Re: Concept Plan Application 10_0193, SIMTA Intermodal Freight Moorebank

SIMTA Intermodal Terminal Proposal

Peer Review of Re-Exhibited Environmental Assessment

Project Number: 112083-02/Report 001 Ver 2

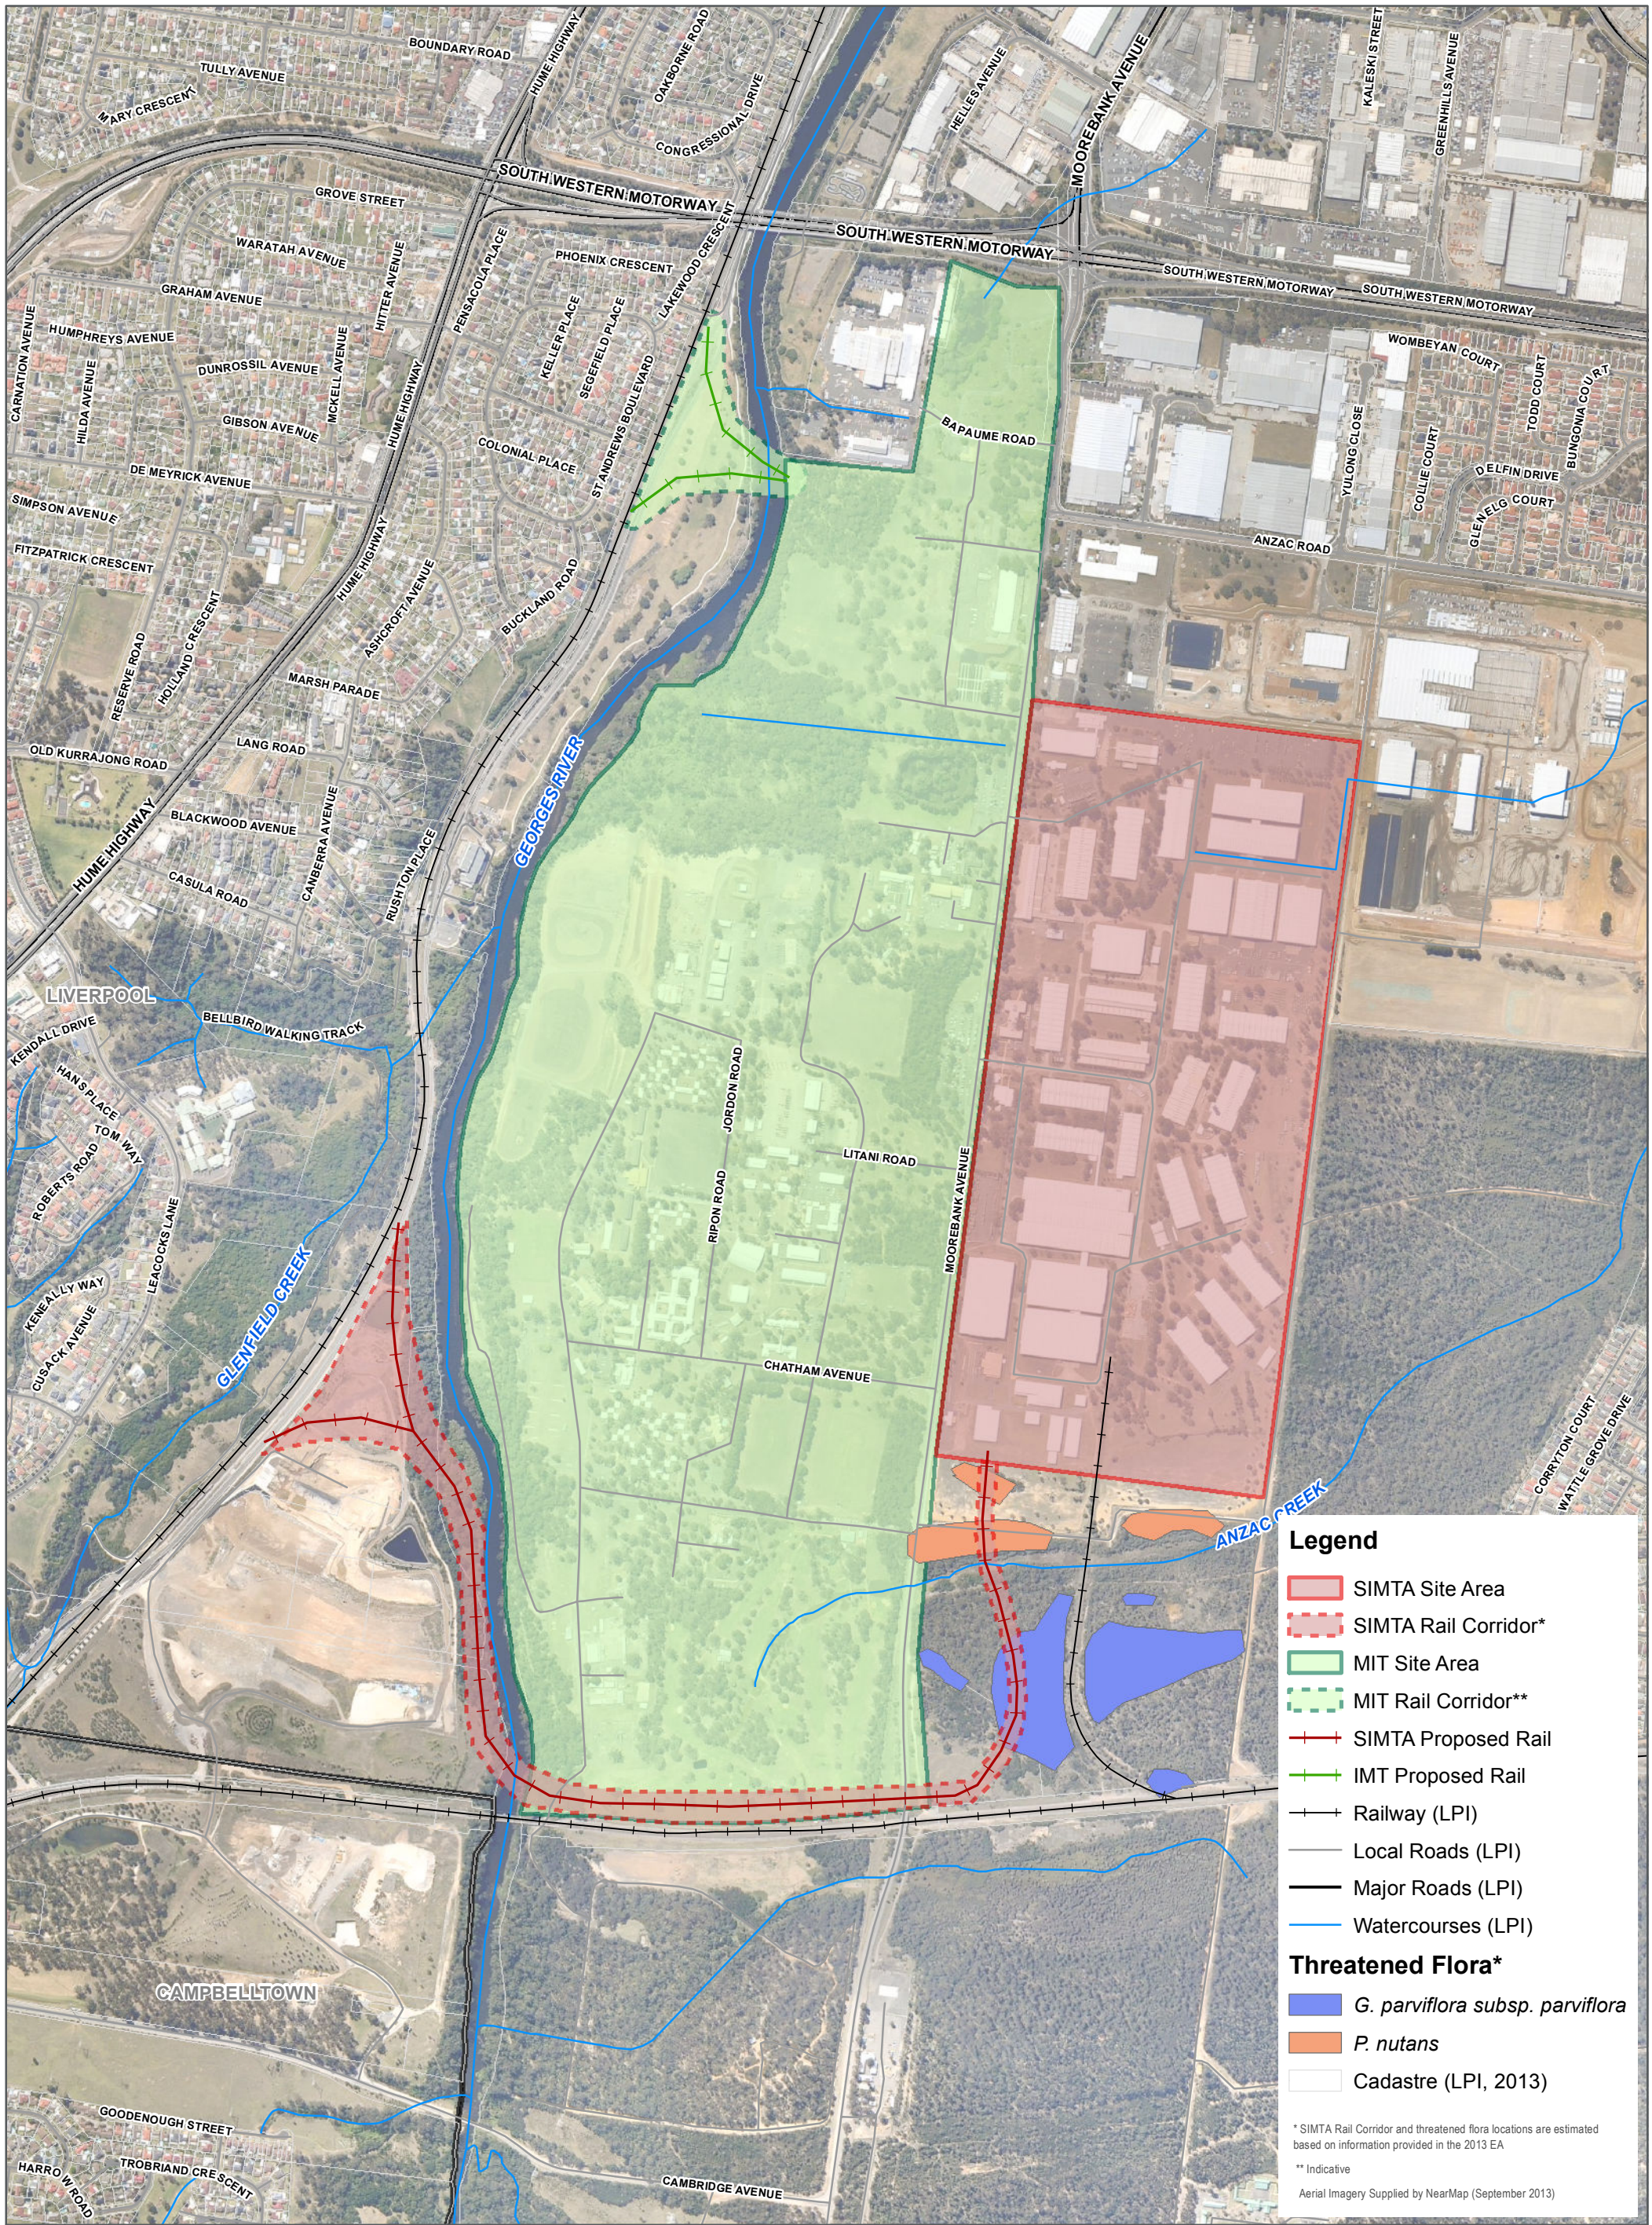
Two separate connections are proposed from the SIMTA and MIT sites to the SSFL, as illustrated in **Figure 2-1** below. The provision of two rail spurs from adjacent sites requires the extensive duplication of rail infrastructure including track work and signalization, which is both resource and land use intensive, with extensive areas of vegetation required to be cleared, particularly for the SIMTA proposal.

A masterplanning process considering both sites in the wider context would help to establish a more coordinated use of the land. This approach would allow land disturbance and impacts on amenity to be minimised while accommodating the likely throughput demand. The masterplanning should be a government led process, with the IMT proponents and key stakeholders involved from the outset.

A more appropriate solution would be for one site to accommodate the identified catchment demand of 1 million TEUs, with a second IMT located elsewhere to service a separate catchment. The separation of the sites would provide a higher level of service to meet the IMT catchment demand, while reducing the distance of truck movements required for transporting freight. Furthermore, the separation of the IMT throughput from the combined 2.7 million TEUs to the demand driven 1 million TEUs, based on the *Freight Demand Modelling* (Hyder, [a], 2013) within the same immediate locality would partially dilute the potentially severe impacts on the amenity of the surrounding area subject to consideration of the cumulative impact comments in **Section 2.5**.

Figure 4-1 Inbound / Outbound Container Movements (Hyder 2013)

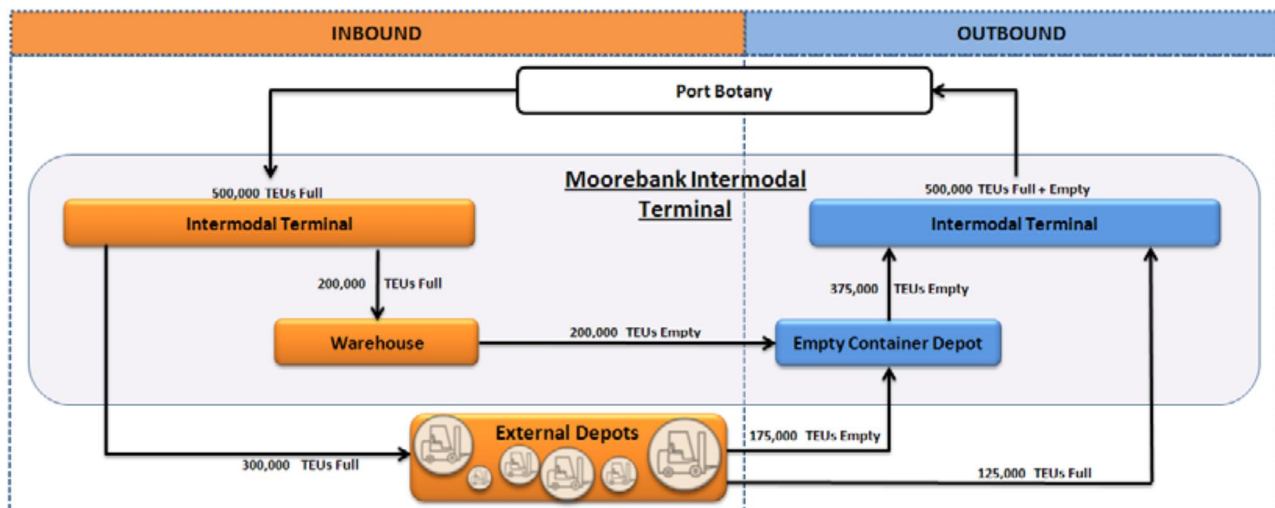
A key issue is that the assessment relies on the assumption that no empty containers leave the empty container depot to be taken out to customer's yards for filling. Although some freight companies may be able to arrange to drop off a newly emptied container to a customer waiting to fill a container without returning to the empty container depot, this would not be the norm. Not all depots and freight customers receive full containers and then immediately re-fill them for transport back to the IMT. Many customers are net exporters and require empty containers to be delivered in order for them to fill. Even if customers receive a full container, empty it and then need to fill a new container, many do not have storage onsite for empty containers or the funds to incur costs for holding the container between when it might be empty and filled, and so would call an empty container to their yard for filling when they are ready rather than keep an empty container on hand.

The movement of empty containers by road out of the SIMTA site appears to be a very real possibility; however, these movements have not been included in the assessment. In **Figure 4-1** below taken from the Transport and Accessibility Impact Assessment (Hyder, [c], 2013), this would be shown as a movement from external depots/customers, to the empty container depot, then back out to external depots/customers, and finally back to the IMT. This trip generation and subsequent impacts on the road network have not been included in the assessment and are potentially significant, given that up to 125,000 TEU's are proposed to be returned full to the IMT.
